11.1.16 Proposed Concrete Batching Plant - Amended Plans to Approved Application - Section 31 SAT Reconsideration

Location: Lot 2, 277-279 Collier Road, Bayswater
Applicant: WA Limestone
Owner: Ransberg Pty Ltd
Officer: Director Planning and Development Services
Refer: Item 11.1.10: OCM 25.8.2015
 Item 11.1.10: OCM 26.5.2015
 Item 11.1.12: OCM 23.7.2013
 Item 11.1.10: OCM 23.4.2013
 Item 15.1.3: OCM 22.11.2011
 Item 11.1.12: OCM 28.6.2011

**Proposed concrete batching plant - WA Premix
SAT mediation - updated advice on environmental risks**

Rev#	Issued for comment	By	Chkd	Appr	Date	Reference Drawings	Drawing No.
1					06/08/15		
2	Details of Revisions

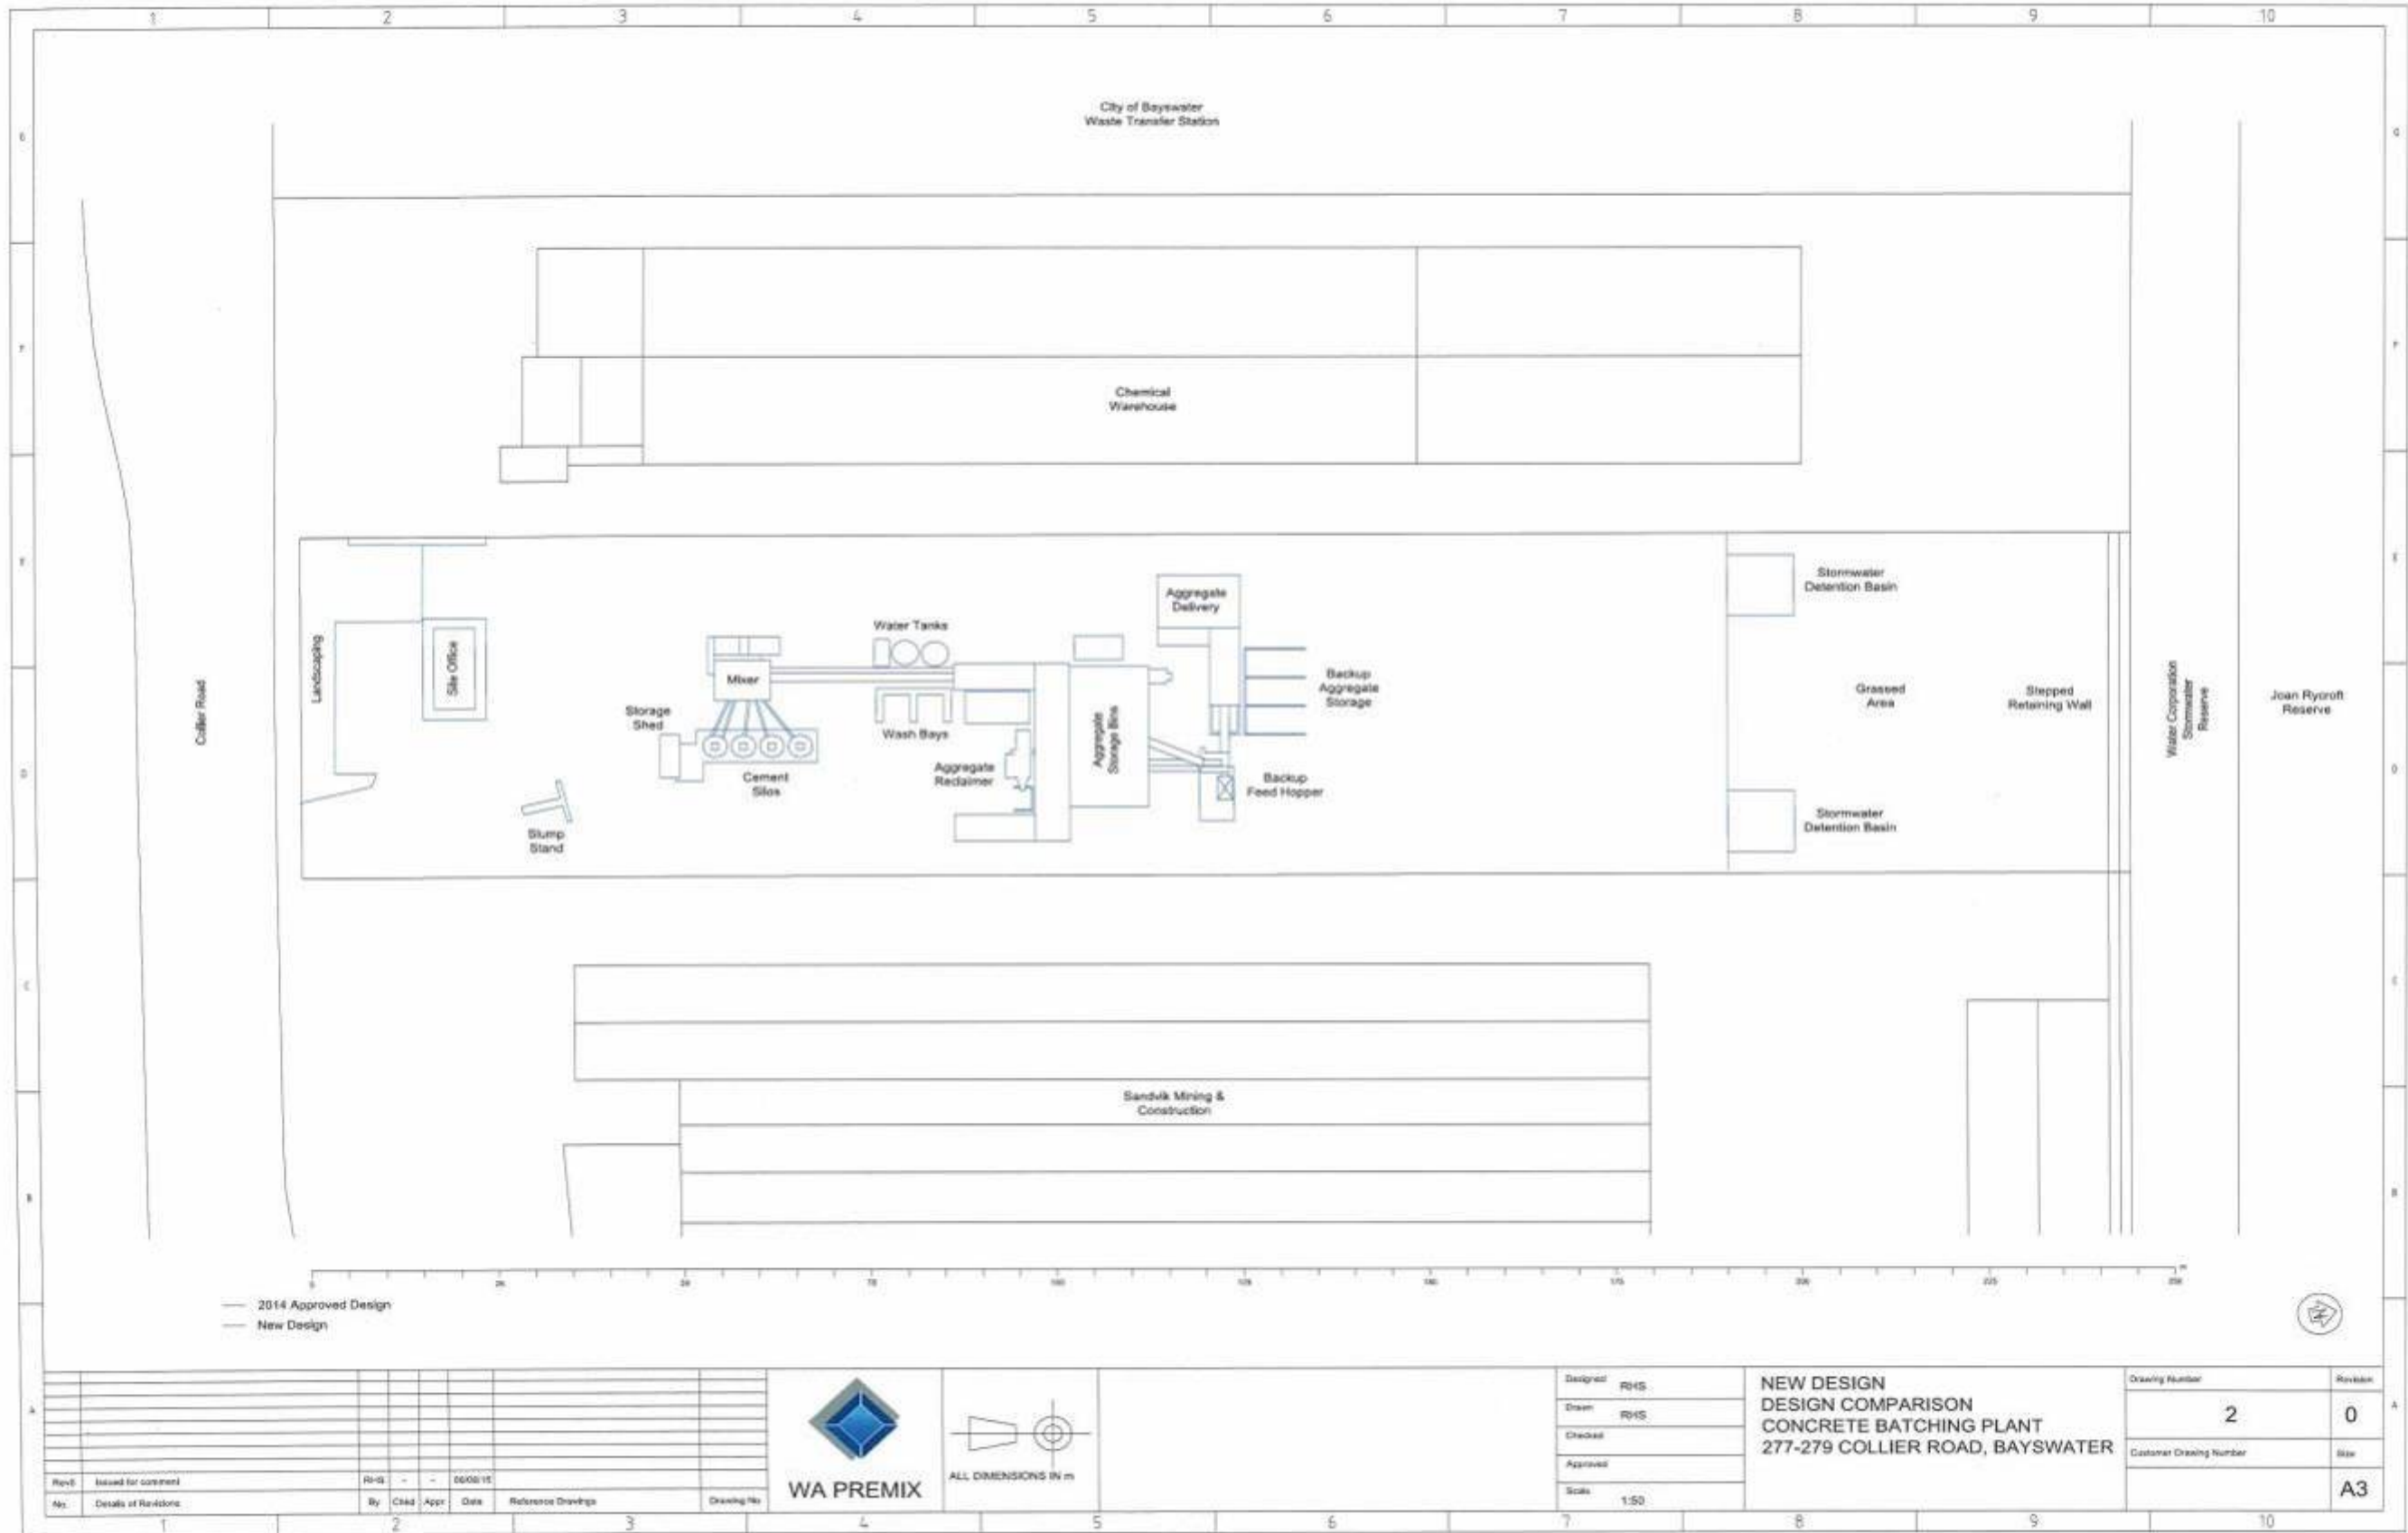
The proposed alterations are considered to improve the applicant's ability to manage dust and noise emissions from the site, given the plant will be mostly enclosed. The amended plans will essentially eliminate the consistent use of front-end loaders which is considered to substantially lower any potential noise impacts.

The original approved SAT application and the amended plans are for a wet-mix plant which is considered to pose less of a risk relating to dust emissions when compared to a dry-mix concrete batching plant. Not only is a wet-mix batching plant considerably better at reducing dust emission than a conventional plant, the amended proposal includes mostly enclosed areas of the process as part of the amended plans. The environmental consultant has advised this process and associated amendments are considered to dramatically reduce impacts relating to dust generation.
